# UNITED STATES PATENT AND TRADEMARK OFFICE

APPLICATION NO.	FILING DATE	FIRST NAMED INVENTOR	ATTORNEY DOCKET NO.	CONFIRMATION NO.
09/640,038	08/16/2000	Christoph Dorr	TRW(EHR)05042	3171

## **DETAILED ACTION**

2,181,300

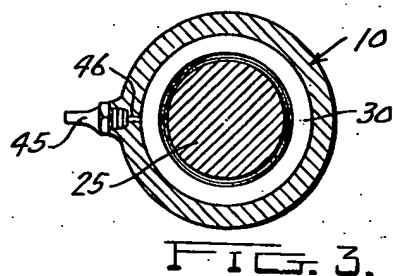
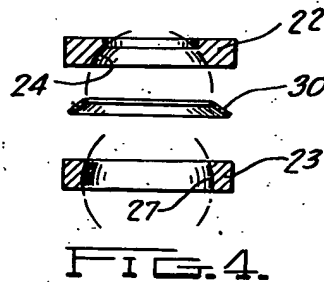
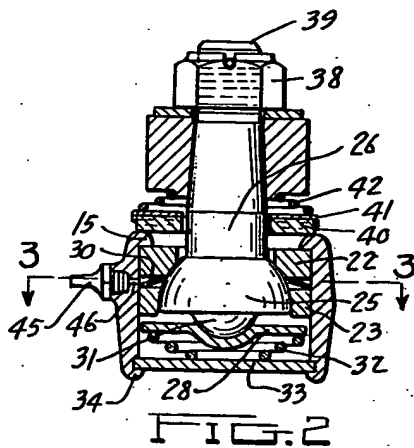
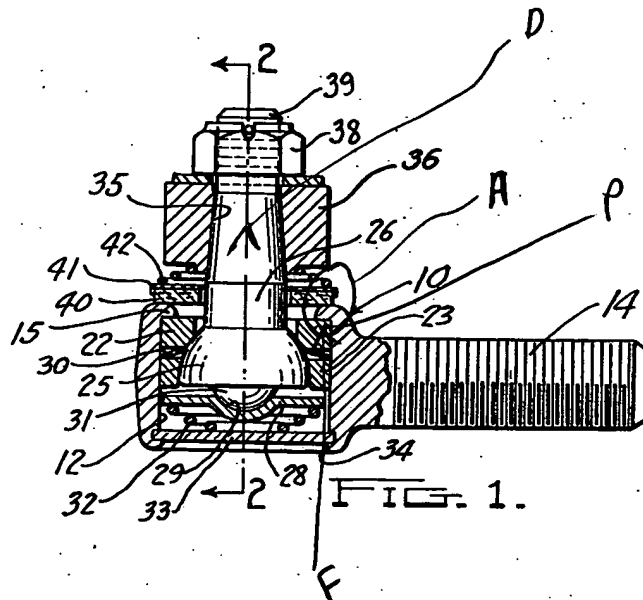
Claims 1, 11, 12 and 16, as best understood, are rejected under 35 U.S.C. 102(b) as being anticipated by Flumerfelt, 2,181,300 (see marked-up attachment).

Regarding claim 1, Flumerfelt discloses in Figure 1 a ball-and-socket joint comprising a joint housing **10**, a ball head **25** with a ball pivot **26**, a bearing shell **22**, and a housing cover **33**. The bearing shell **22** is disposed between the ball head **25** and the joint housing **10**. A compressive force **F** is between the housing cover **33** and at least a portion **P** of the bearing shell **22**. The compressive force **F** permanently acts on the portion **P** and in an axial direction **D**.

Regarding claim 11, the bearing shell **22** is divided into an upper shell **22** and a lower shell **23**.

Regarding claim 12, a spring element **30** is arranged between the upper shell **22** and the lower shell **23**.

Regarding claim 16, an area **A** of the bearing shell **22**, facing in the direction **D**, is preferably cylinder-shaped.

Fig.4

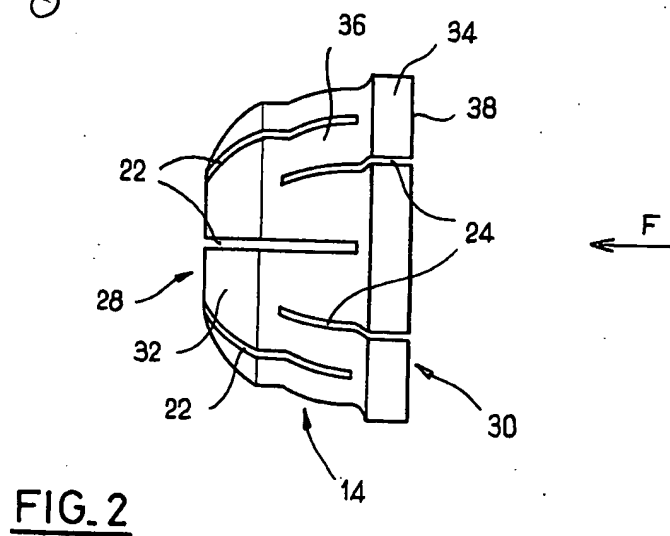
Claims 1, 11 and 14, as best understood, are rejected under 35 U.S.C. 102(b) as being anticipated by Dresselhouse, 5,154,530 (see marked-up attachment).

Regarding claim 1, Dresselhouse discloses in Figure 4 a ball-and-socket joint comprising a joint housing **20**, a ball head **64** with a ball pivot **106**, a bearing shell **24**, and a housing cover **30**. The bearing shell **24** is disposed between the ball head **64** and the joint housing **20**. A compressive force **C** is between the housing cover **30** and at least a portion **P** of the bearing shell **24**. The compressive force **C** permanently acts on the portion **P** and in an axial direction **x**.

Regarding claim 11, the bearing shell **24** is divided into an upper shell **92** and a lower shell **122**.

Regarding claim 14, the upper shell **92**, on a side **S** of the housing cover **30**, has a collar **70** and the collar **70** is wedged between the housing cover **30** and a shoulder **72** of the joint housing **20**.
